PLANNING COMMISSION MEETING

LOCATION: TOWNSHIP ANNEX, 7527 HIGHLAND ROAD, WHITE LAKE, MI 48383
THURSDAY, SEPTEMBER 05, 2024 – 6:30 PM

**WHITE LAKE TOWNSHIP
PLANNING COMMISSION
AUGUST 15, 2024**

DESIGNED BY: ST
 DRAWN BY: DH
 CHECKED BY:
 SCALE: 1" = 40'
 JOB NO: 22-029-1
 DATE: 05/30/24
 SHEET NO. 8

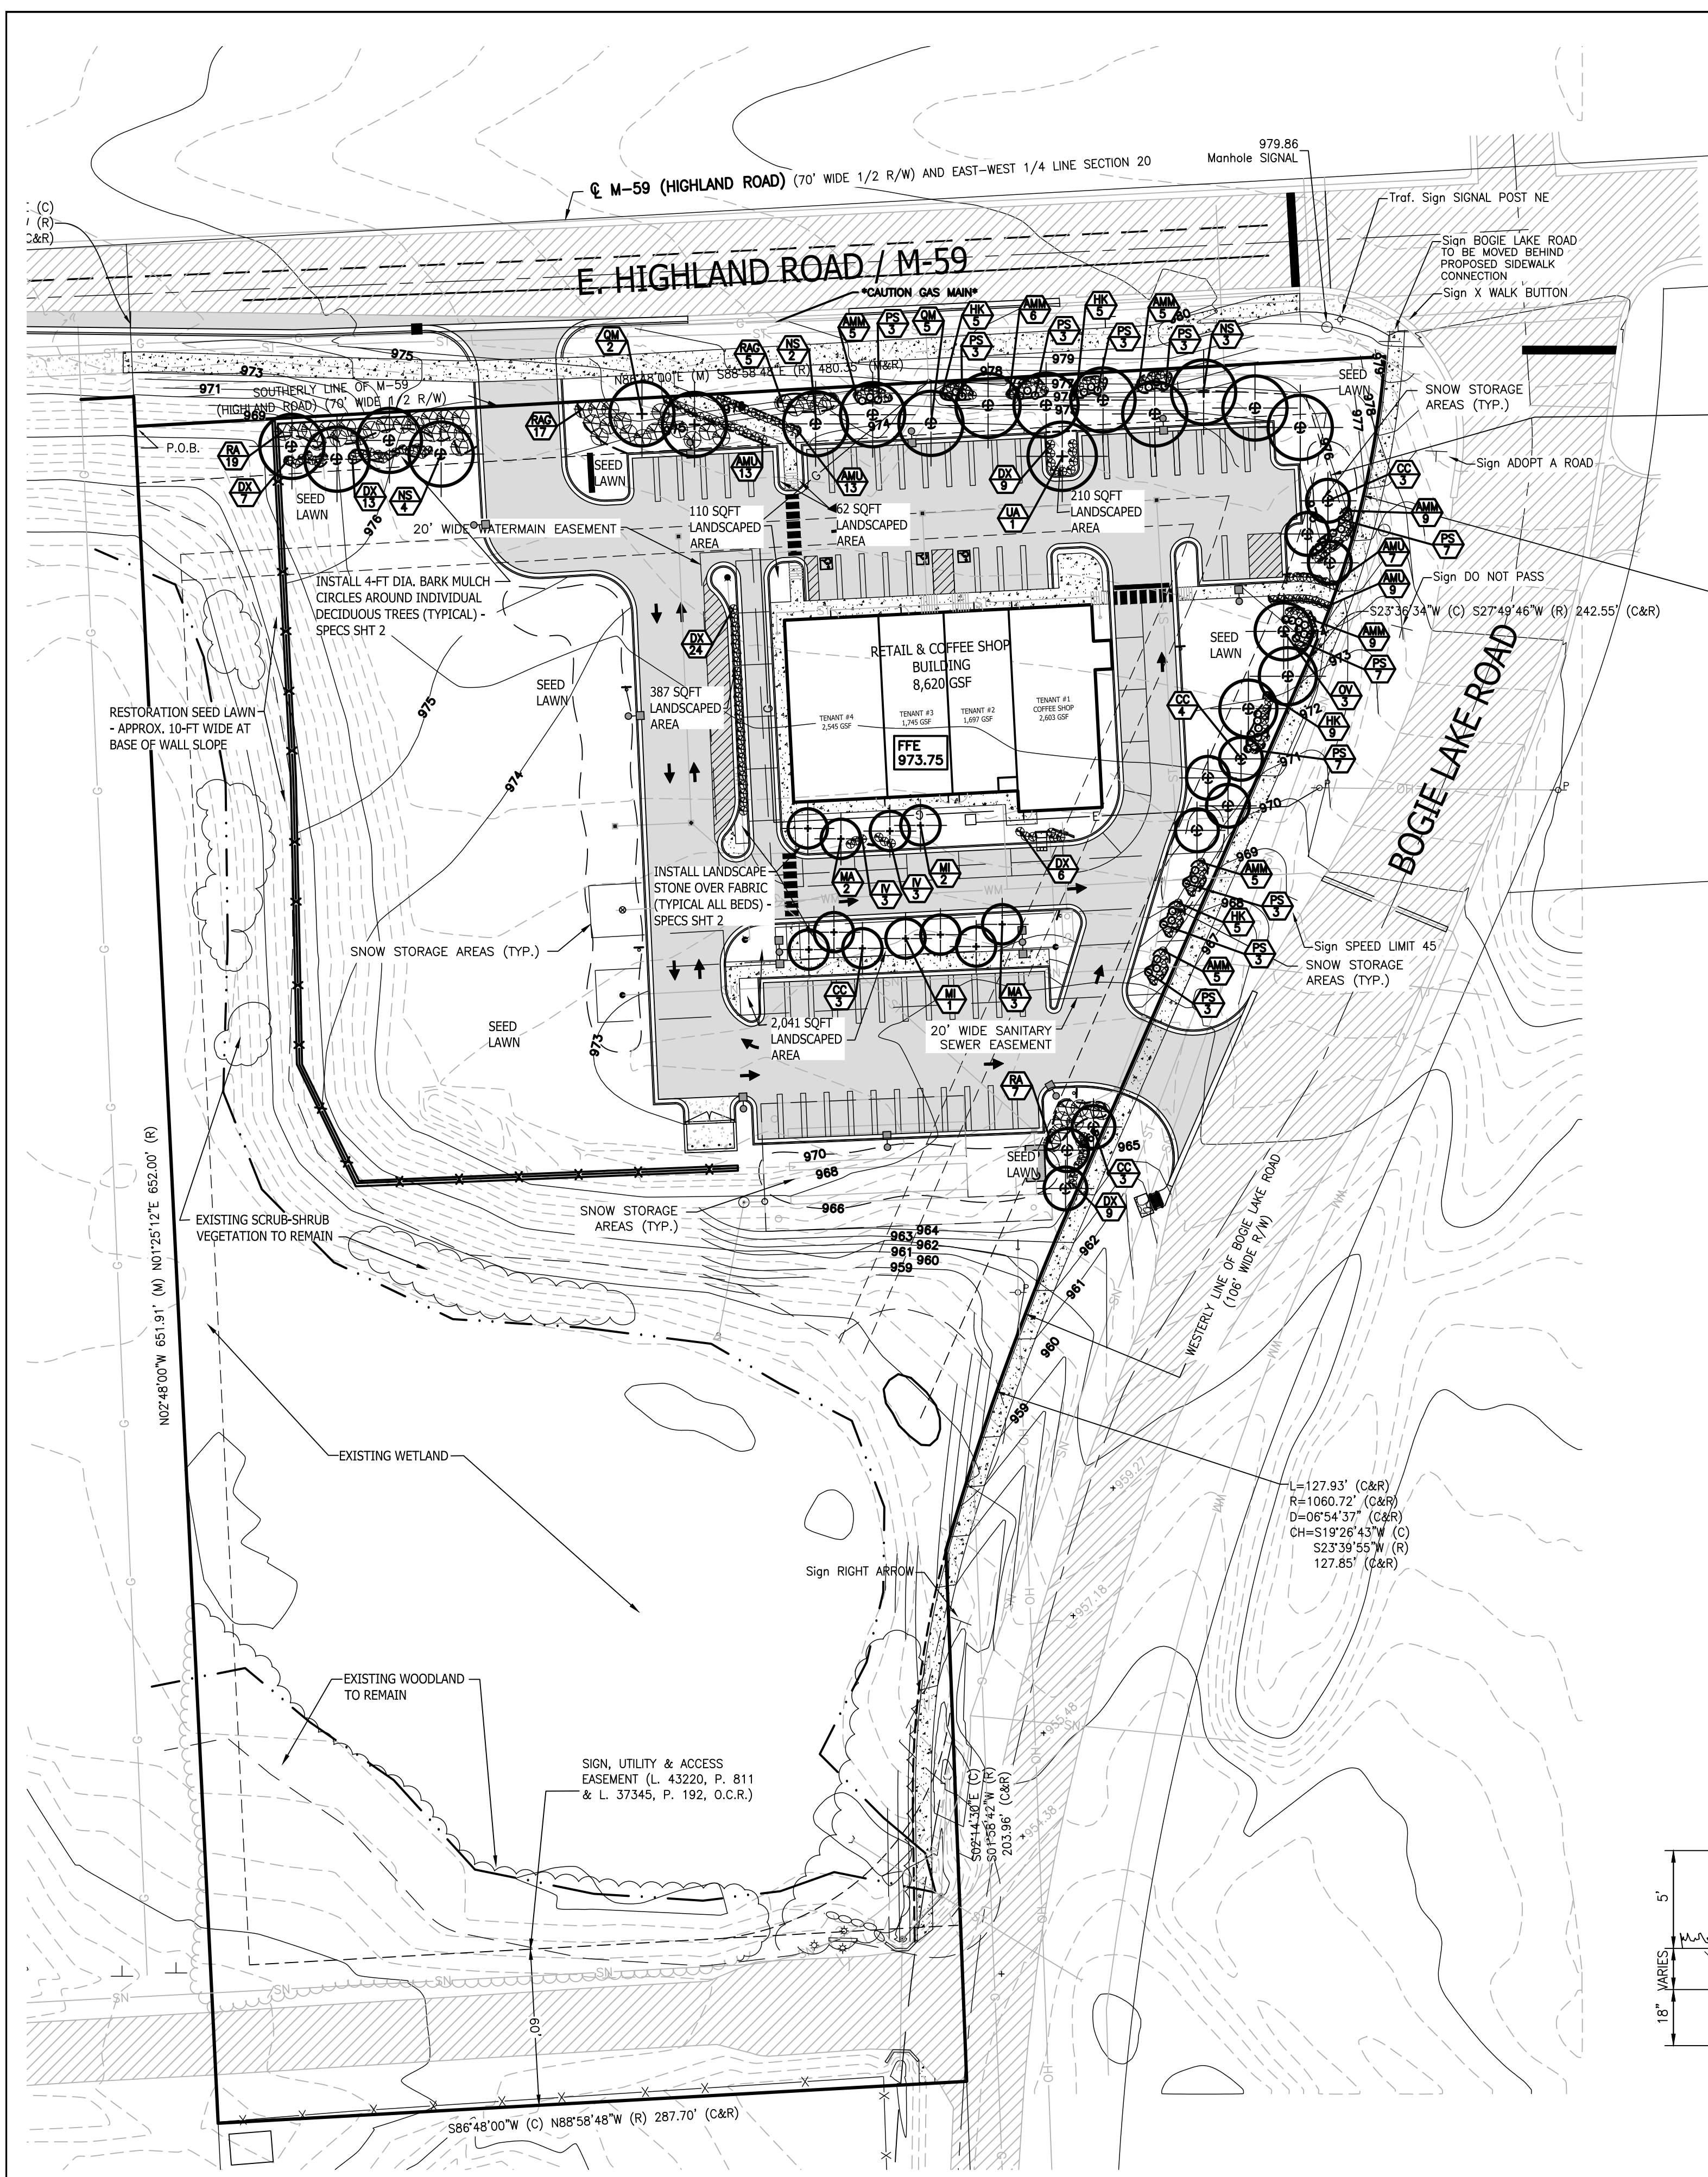
9. *Sheet 8—Correct spelling of ‘sedimentation’ on title bar.* **Comment addressed. Spelling has been corrected.**
10. *Sheet 8- Remove General Notes information; this is in duplicate and is on Sheet 4.* **Comment addressed. Notes have been removed from Sheet 8.**

11. *Sheet 8- Soil Erosion Notes- Note 1- Remove ‘Oakland County Drain Commissioner’ and add ‘OCWRC.’* **Comment addressed. Note has been updated.**
12. *Sheet 8- Soil Erosion Notes- Note 2- Change sheet number from 15 to Sheet 20.* **Comment addressed. Sheet reference has been updated.**

13. *Sheet 8- Proposed Construction Schedule for the Year 2024- Please update as needed.* **Comment addressed. Schedule has been updated.**
14. *Sheet 8-The silt fencing location relative to the area of the proposed west retaining wall may be too tight with what is realistically needed for construction of the wall. Please verify and adjust as needed.* **Comment addressed. Silt fencing has been shifted further west to realistically allow for retaining wall construction.**

15. *Sheet 8- Relocate/wrap silt fencing in the area of the basin ES installation such that the silt fencing is around this area and that wetlands is protected.* **Comment addressed. Additional silt fencing is now shown around area of basin ES construction.**
